PLANNING BOARD PORTSMOUTH, NEW HAMPSHIRE

7:00 PM MARCH 25, 2021

Subject: Staff Recommendations for the March 25, 2021 Planning Board Meeting

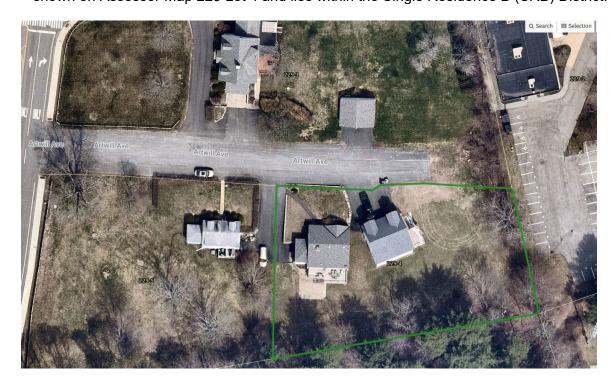
This stipulation was added to allow for the passage of wildlife underneath the fence.

Vote to approve the Wetland Conditional Use Permit as presented with the following stipulation:

SITE PLAN W/ PARKING

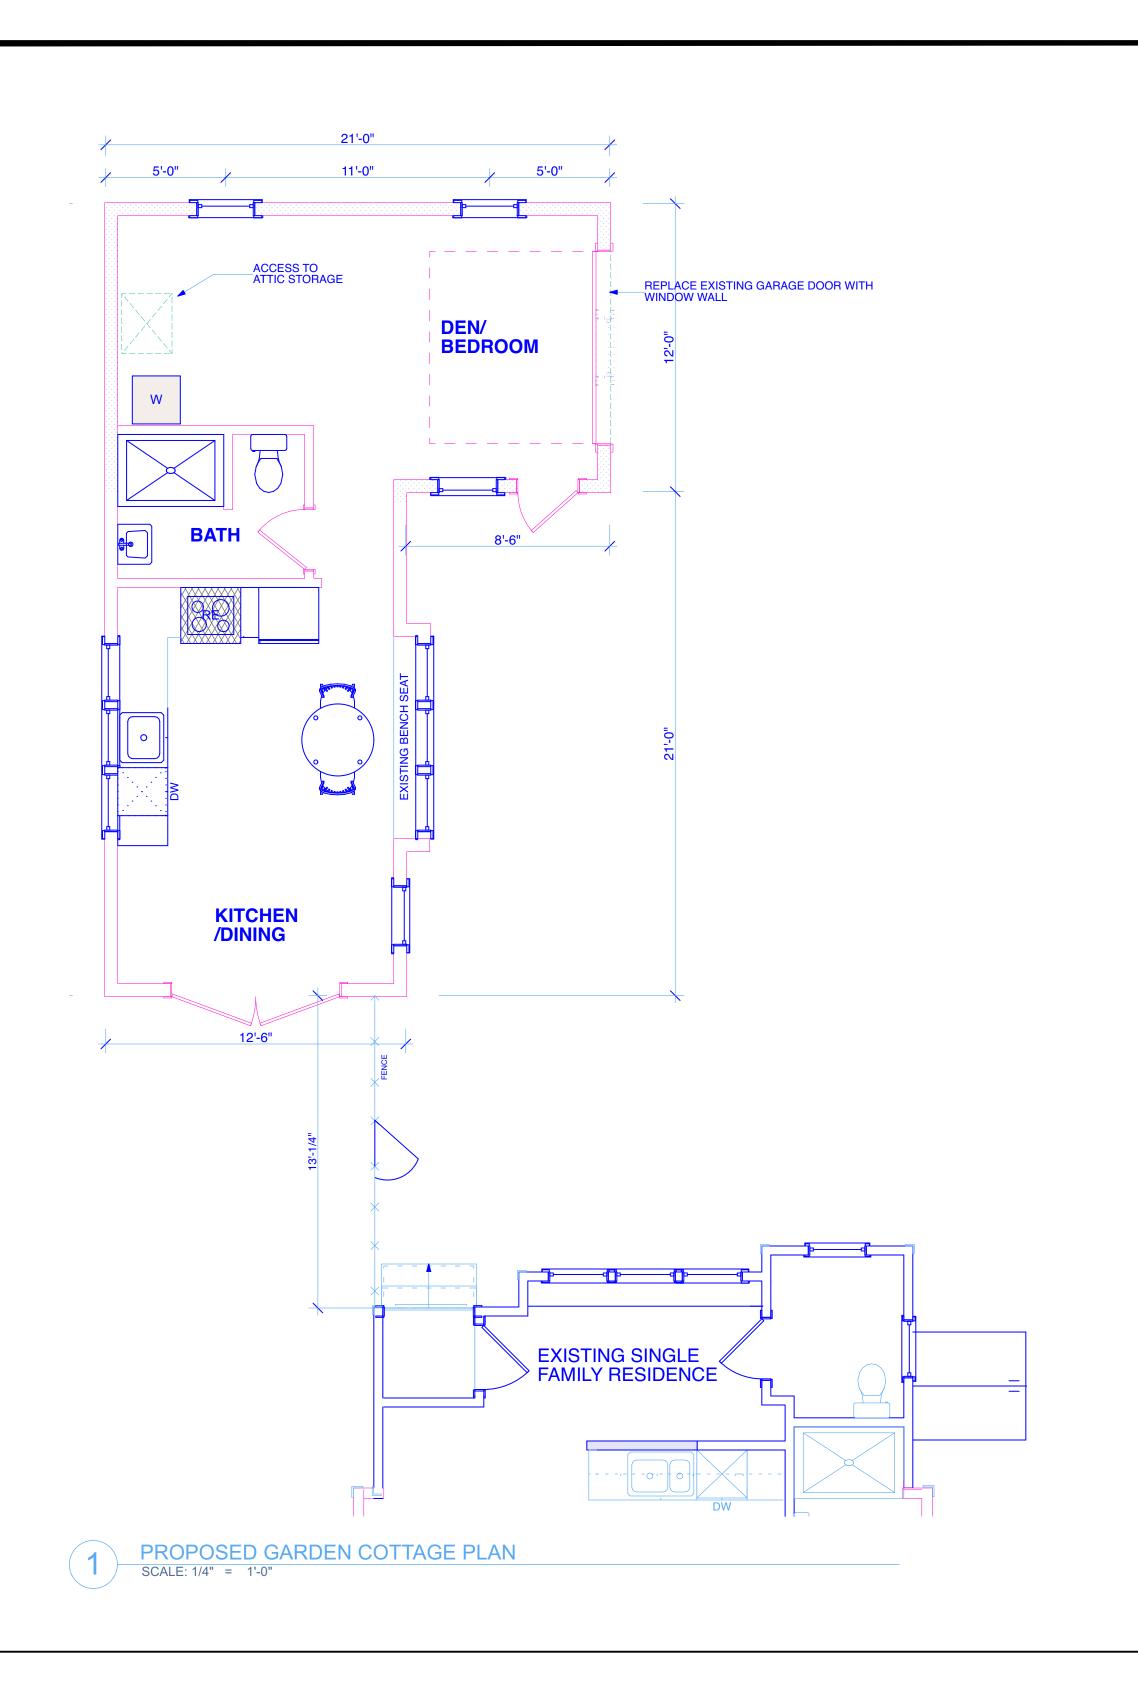
2. The site plan provides adequate open	The property has an existing backyard	
space, landscaping and off-street parking for	that is proximate to both the Garden	
both the Garden Cottage and the primary	Cottage and the primary dwelling. 4	
dwelling.	off-street parking spaces are provided,	
	which exceeds the minimum	
	requirements of the Zoning Ordinance

- 1) Vote to find that the requested modification to allow the existing windows to remain will be consistent with the required findings of Section 10.815.40 and to grant a modification to the requirements of Section 10.815.33 as requested by the applicant.
- 2) Vote to find that the application meets the requirements of Section 10.815.40 and to grant to grant the conditional use permit as presented, with the following stipulation:
 - 2.1) In accordance with Sec. 10.815.70 of the Zoning Ordinance, the owner is required to obtain a certificate of use from the Planning Department verifying compliance with all standards of Sec. 10.815, including the owner-occupancy requirement, and shall renew the certificate of use annually.
